Dealer Service Instructions for:

Safety Recall No. A10 -- Fuel Tank Blocker Bracket

Models**2002 (WJ) Jeep® Grand Cherokee**

Figure 5

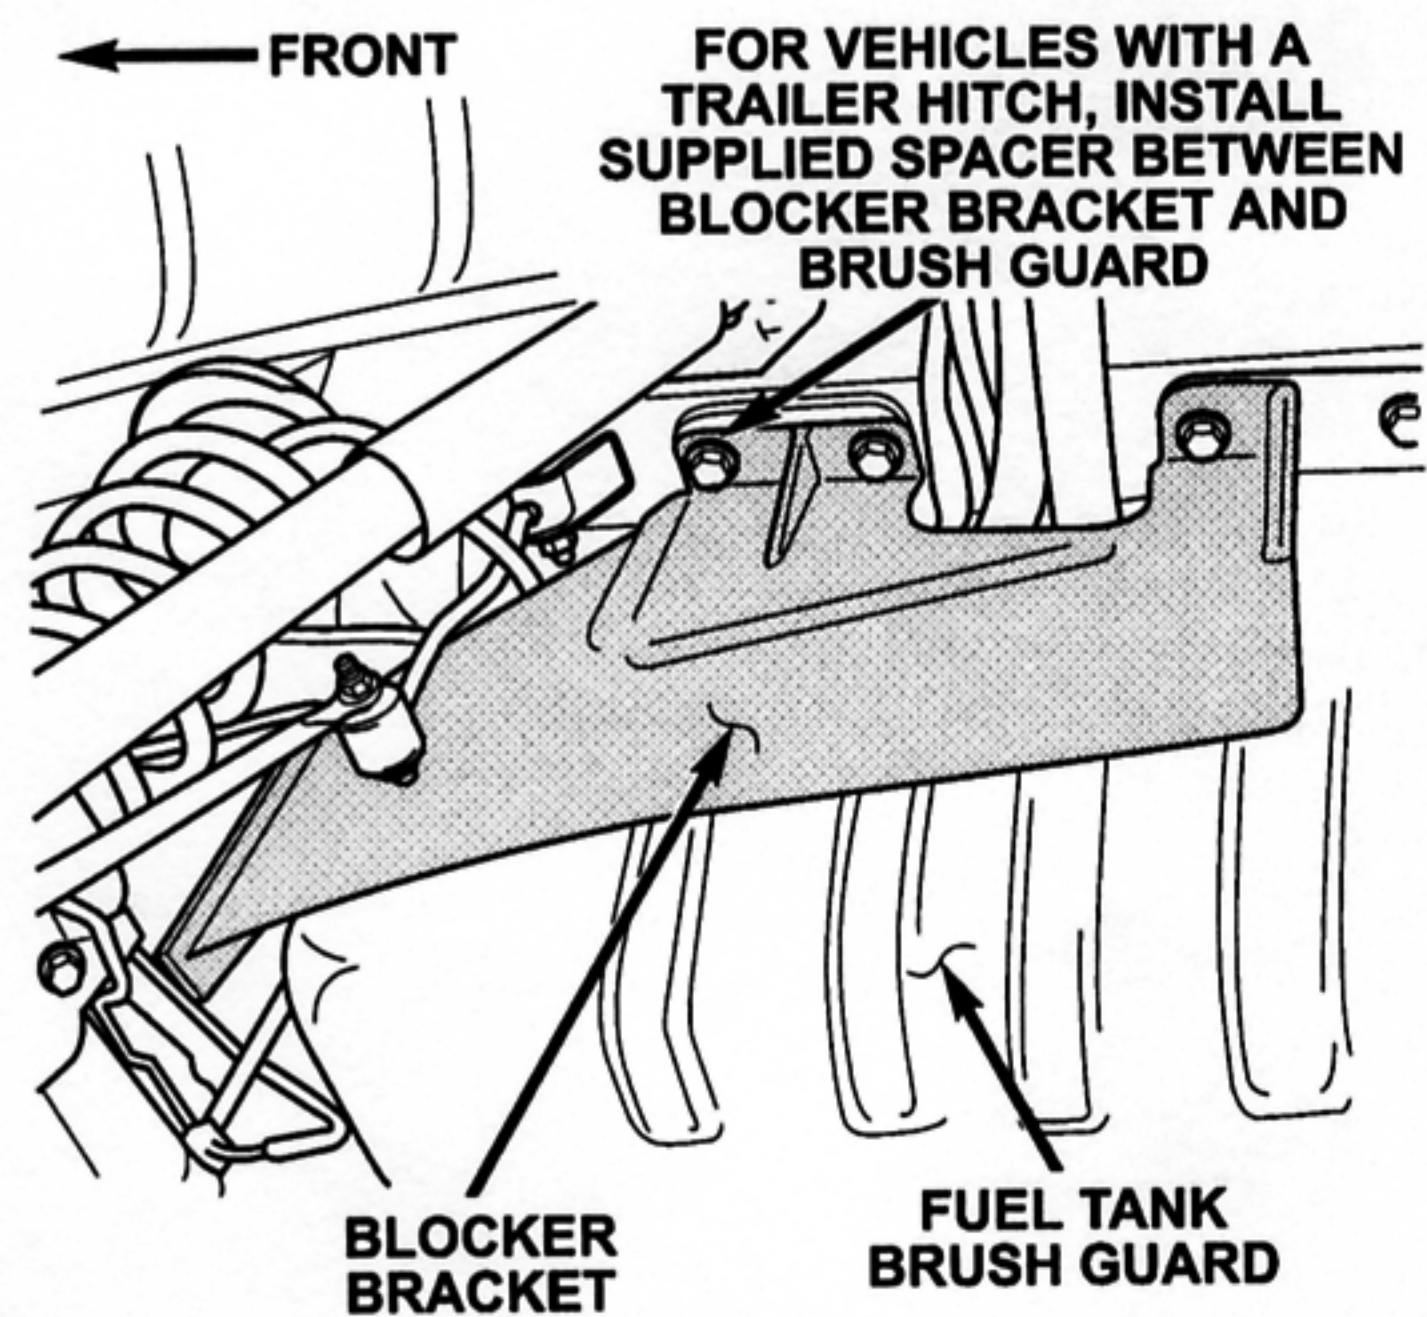
11. With an assistant holding the tank assembly in the right-most position, and using a 12 inch extension, tighten the three right and the rear-most left, brush guard bolts to 65 ft-lbs (88 N·m).
12. **For vehicles equipped with a trailer hitch,** tighten the two (2) rear-most trailer hitch bolts to 65 ft-lbs (88 N·m).
13. Install the fuel tank blocker bracket adjacent to the left side of the fuel tank brush guard (Figure 5).

IMPORTANT: For vehicles equipped with a trailer hitch, install the supplied spacer between the blocker bracket and the brush guard at the forward-most bolt hole location.

14. Position the blocker bracket as far to the right as possible (next to the brush guard) and then install the fuel tank brush guard/trailer hitch mounting bolts (Figure 5). Using a 12 inch extension, tighten the bolts to 65 ft-lbs (88 N·m).

IMPORTANT: Tighten the forward-most blocker bracket bolt first.
